2.0

PROPOSED SCHEME CHANGES

2.2 GROUND FLOOR PLAN

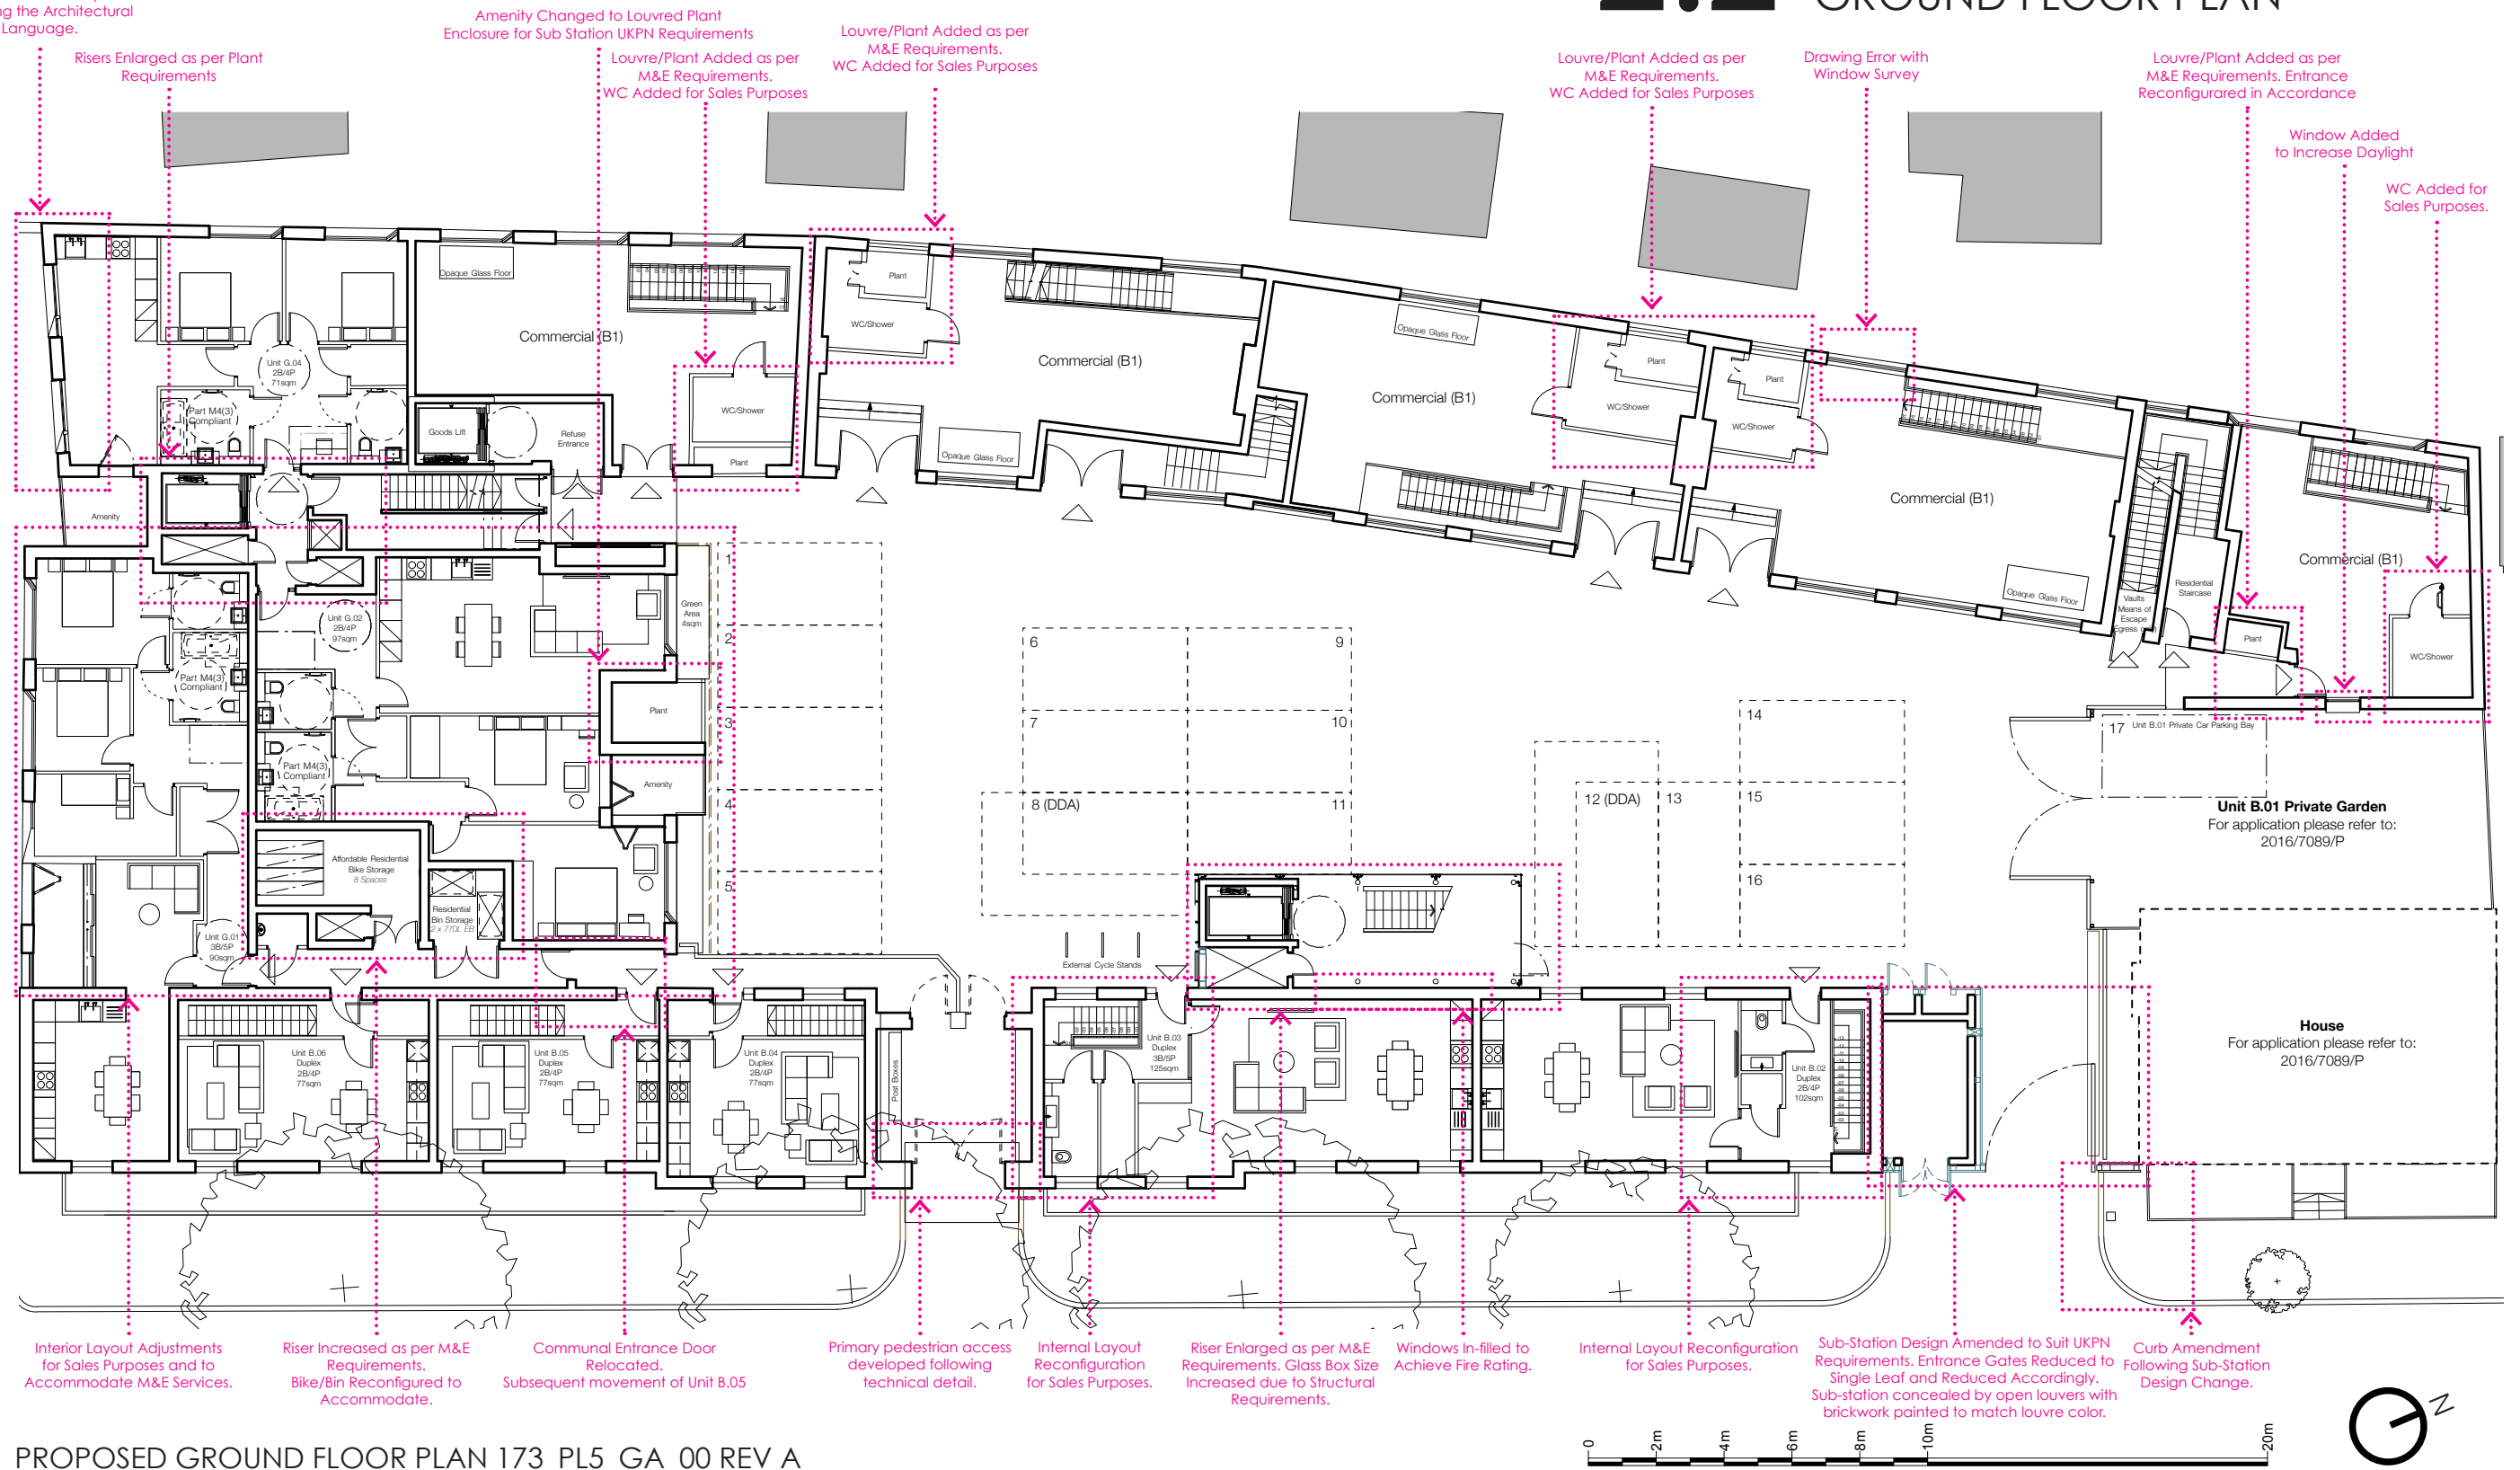
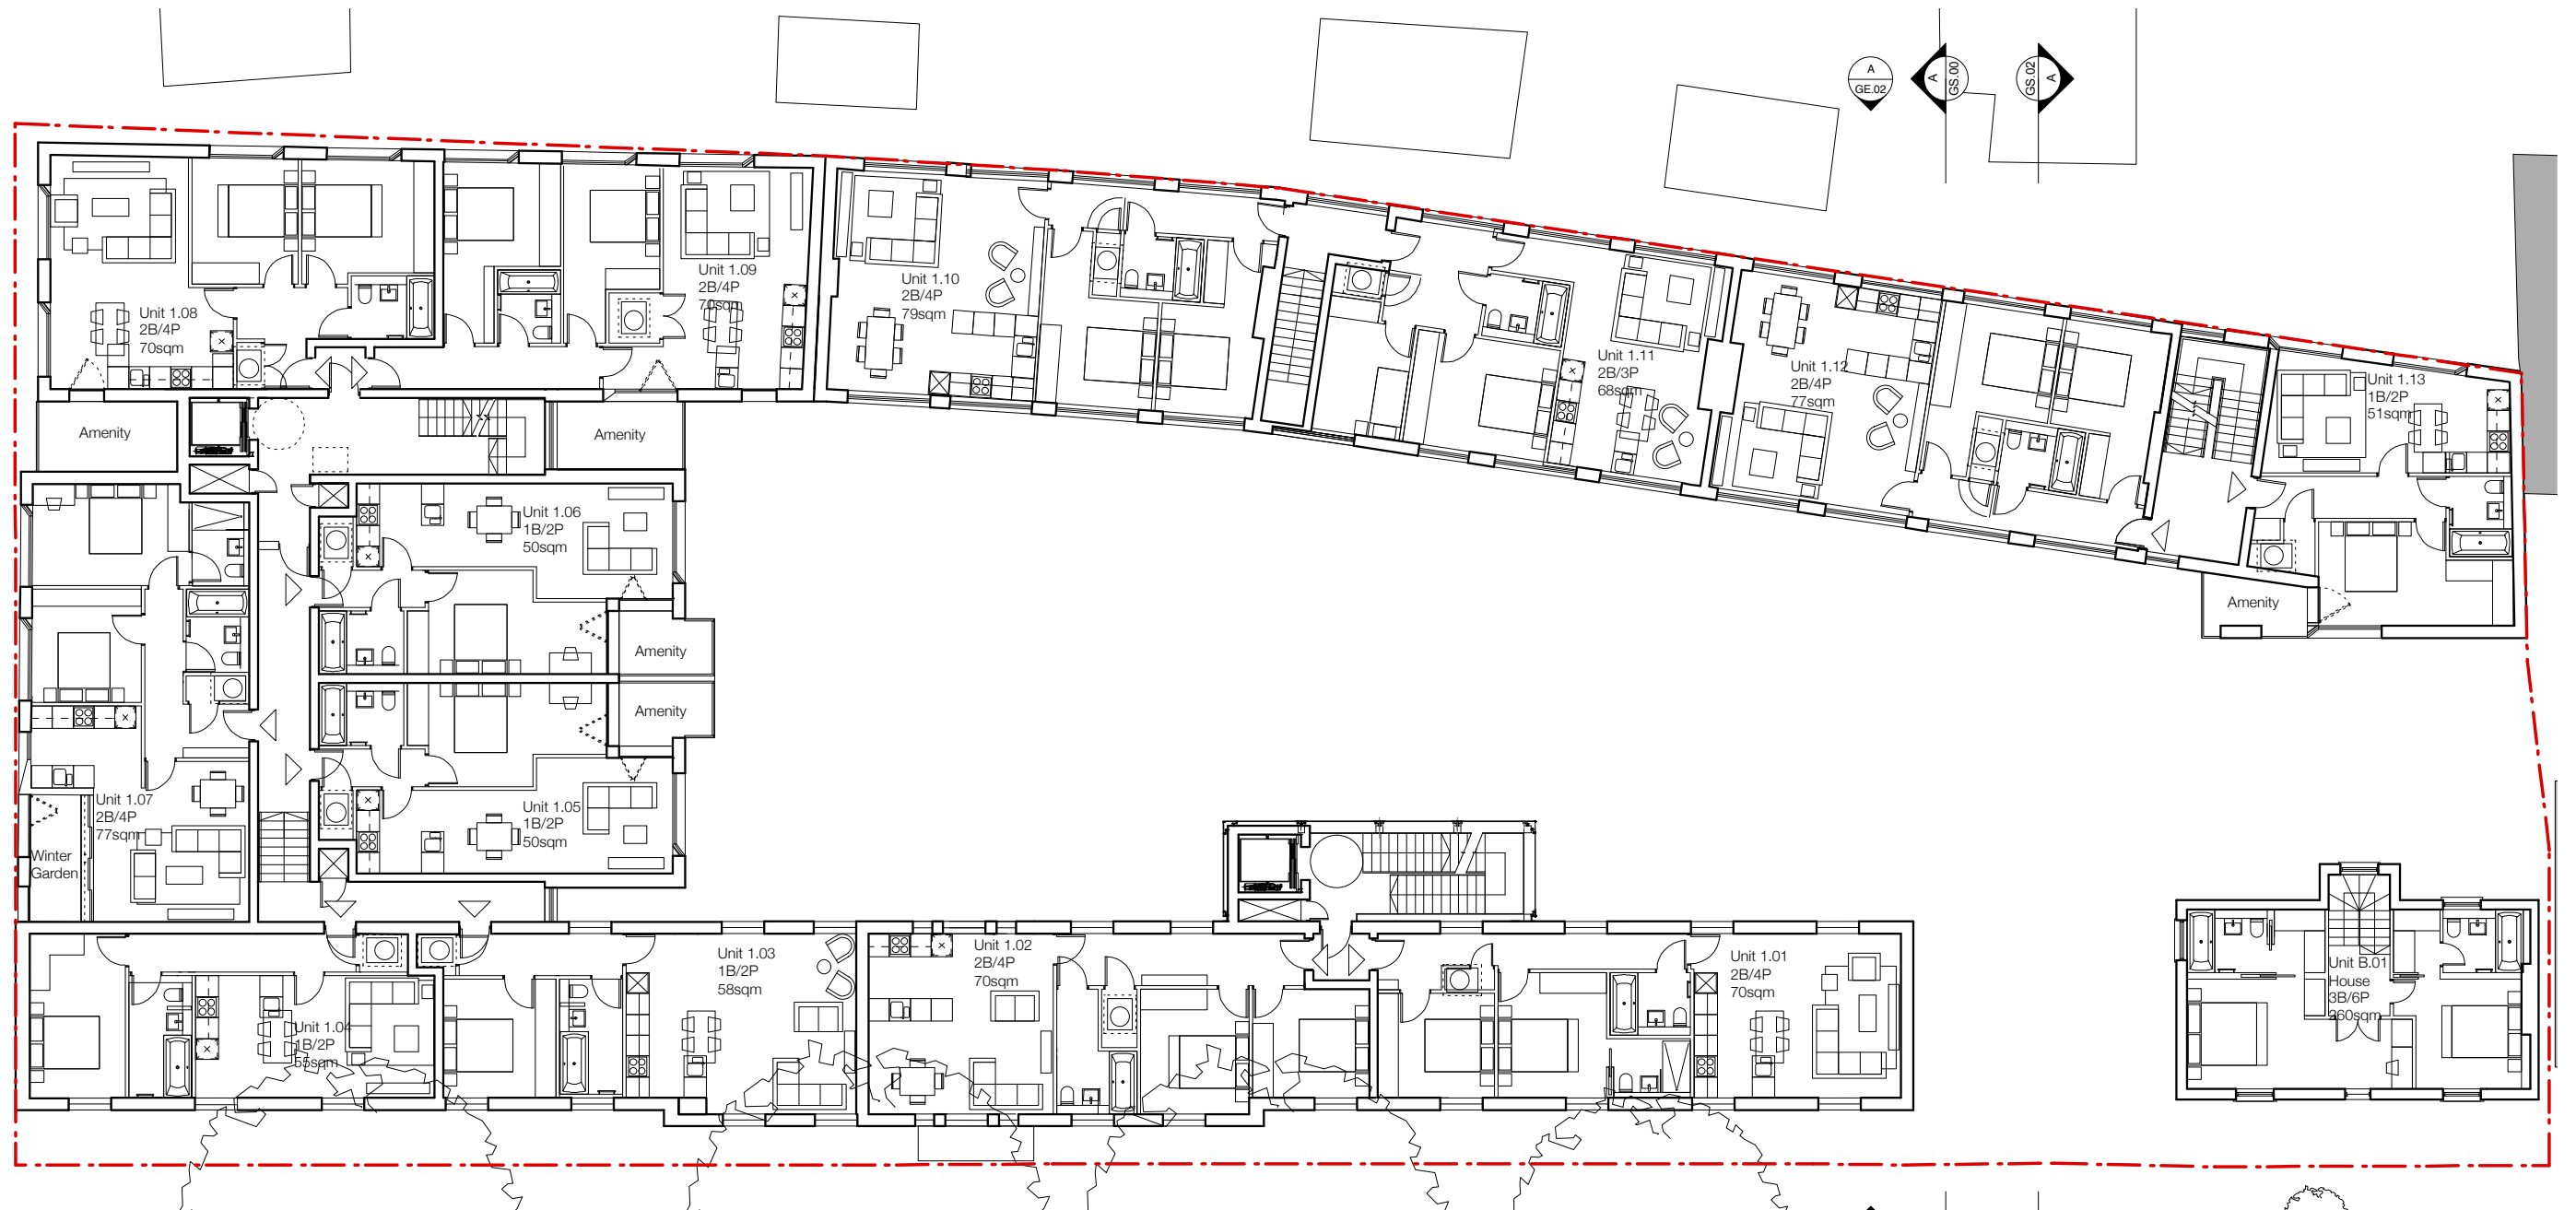
Building Facade Angle
Adjusted for Buildability whilst
Retaining the Architectural
Language.
